Our query relates to the North and South core area windows which run vertically from Level 1 to Level 33 in one continuous strip (shown on attached elevation Drawing No. (25) 025).

Fig 1: Window in plan

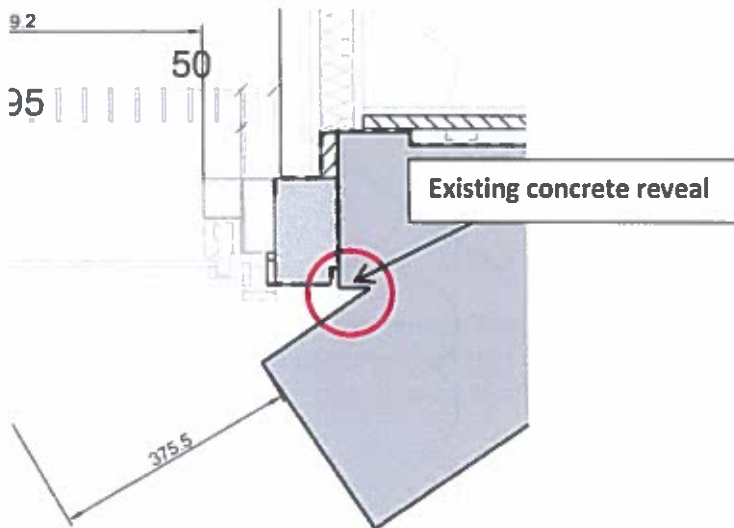
The plan below demonstrates that the window element and flashings beside it are aligned with the face of the existing concrete and the existing concrete reveal remains visible and is shown in the attached approved drawing (Drawing No. (25) 131).

The approved detail shown in (25) 131 cannot be achieved technically due to the variances in the concrete line and level throughout levels 1 to 33. It would not be possible to keep a uniform silicone sealant joint between the window frame and the existing concrete.

Proposal

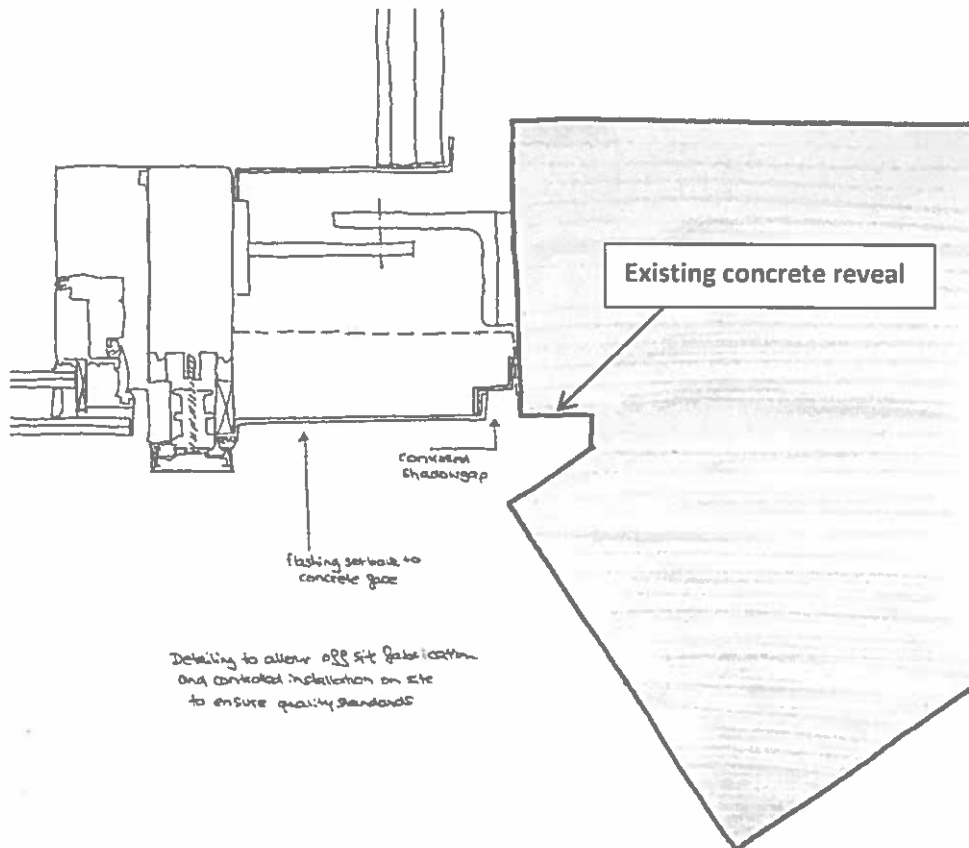
We have therefore produced the below design solution which is very similar to the approved scheme that will allow for buildable fit out of the windows.

The variances in the concrete line and level between the floors will be overcome with the use of a controlled shadow gap, keeping a uniform visible gap throughout levels 1 to 33. This will replace the silicone joint as shown in the below detail. The existing concrete reveal will remain visible and the outside face of the window will remain aligned with the existing concrete reveal as per the approved detail.
